Subject: Redondo Beach Energy Project (12-AFC-03)
South Coast Air Quality Management District's Request for Information

Subject: Redondo Beach Energy Project Permit Application (Facility ID# 115536)

AES Redondo Beach, LLC (AES) is submitting this letter in response to the South Coast Air Quality Management District's (AQMD) April 12, 2013 request for additional information needed to complete the engineering evaluation of the Redondo Beach Energy Project (RBEP). The remainder of this letter presents AES's responses to the requested information.

FIGURE 1
 Typical Aboveground 3000 Gallon Oil Water Separator
 AES Redondo Beach Energy Project
 Redondo Beach, California

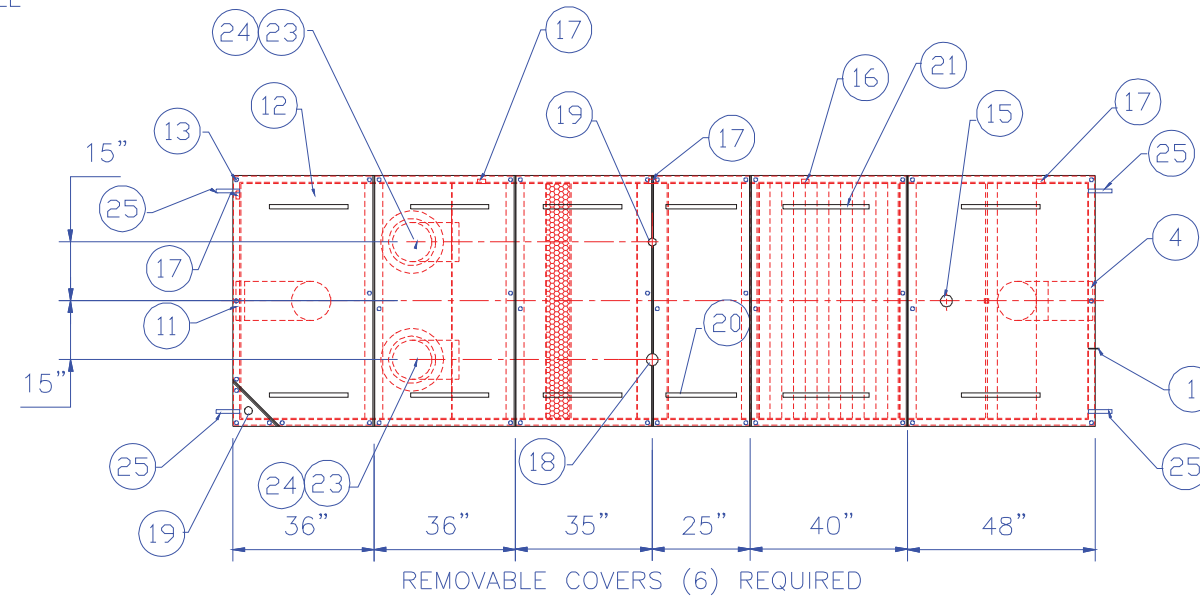
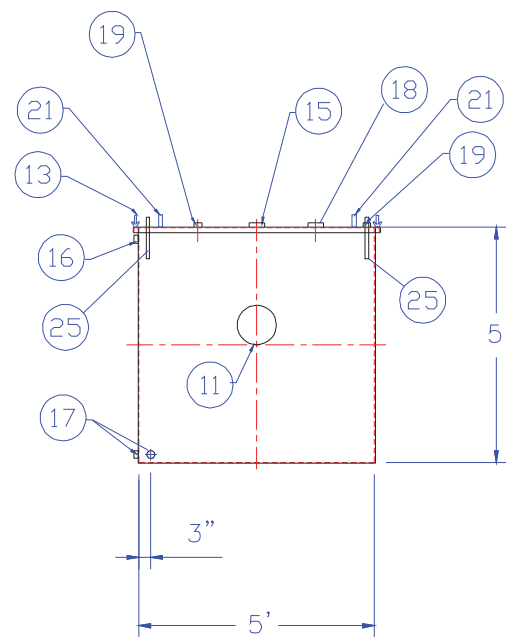
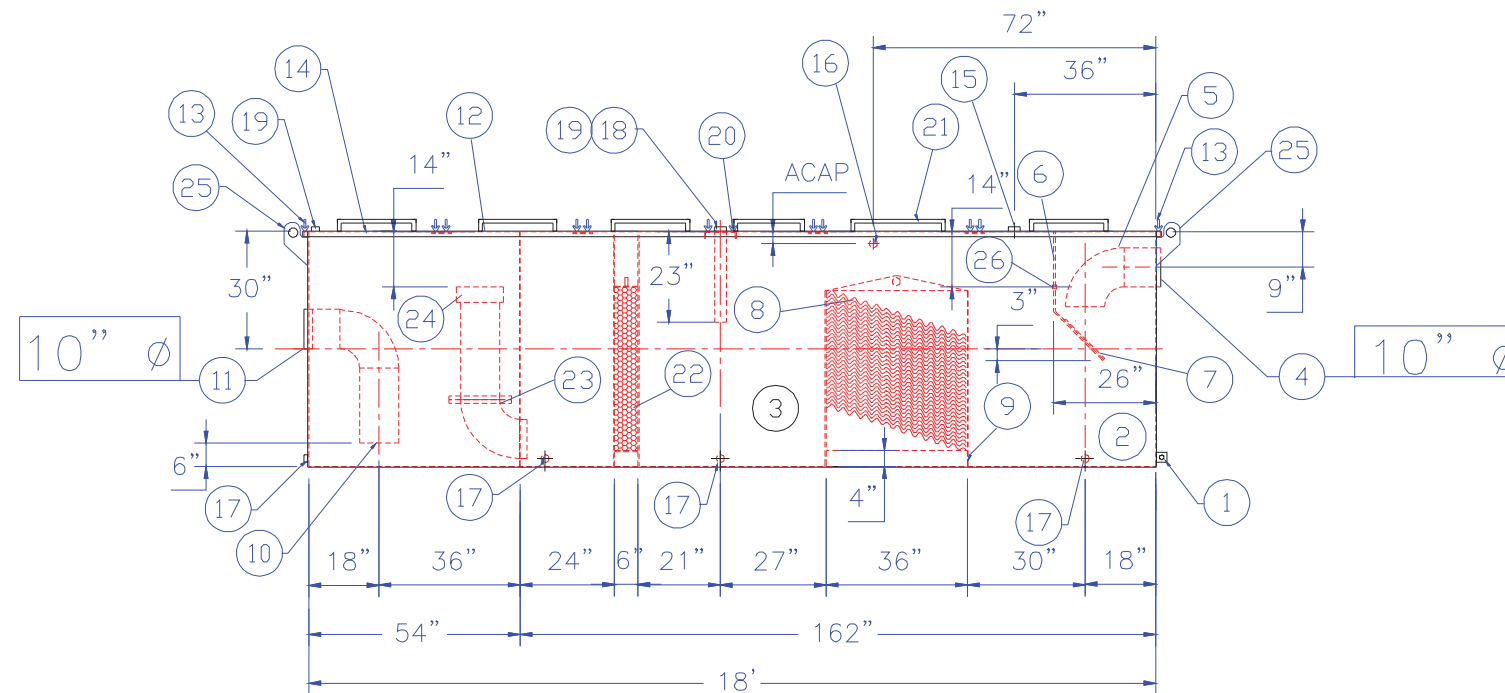
4) Application for Oil/Water Separator – In response to Item 8, you submitted Form 400-A and a check for \$5,229.18 for an application for an oil/water separator. The \$5,229.18 apparently included \$1,789.12 for a second RECLAIM/Title V facility amendment application. Since Application No. 545065 will serve as the RECLAIM/Title V facility amendment application for the entire project, \$1,789.12 will be refunded. To complete the application, please provide a completed Form 400-E-18 – Storage Tanks and emission calculations.

Response: The RBEP oil/water separator will treat precipitation that falls on lubricant-containing equipment. The proposed oil/water separator is a single-wall aboveground 3,000-gallon horizontal carbon steel tank, measuring 18 feet long with a width and height of 5 feet, rated at 300 gallons per minute. The separator includes a 10-inch inlet and outlet port, six removable covers, one, 3-inch clean-out port, a 2-inch vent port, four, 2-inch drain ports, and a 2-inch inlet and outlet port. The tank will operate at ambient temperatures and pressure. The removable covers and ports will include gaskets to reduce fugitive emissions. The expected annual average precipitation in the project area is

12.02 inches.⁷ Based on the areas at RBEP which drain to the oil/water separator, the annual expected oil/water separator throughput is approximately 82,000 gallons. Using a controlled emission factor of 0.2 pounds of VOC per 1,000 gallons of water processed⁸, the annual expected VOC emissions would be 16.4 pounds per year. Assuming 25 percent of the annual rainfall occurs within a single month, the maximum monthly throughput of the oil/water separator would be 20,500 gallons and the monthly VOC emissions would be 4.1 pounds or 0.1 pounds per day. Attachment 2 contains the requested Form 400-E-18 for the oil/water separator and a Figure 1 showing a typical 3,000-gallon oil/water separator.
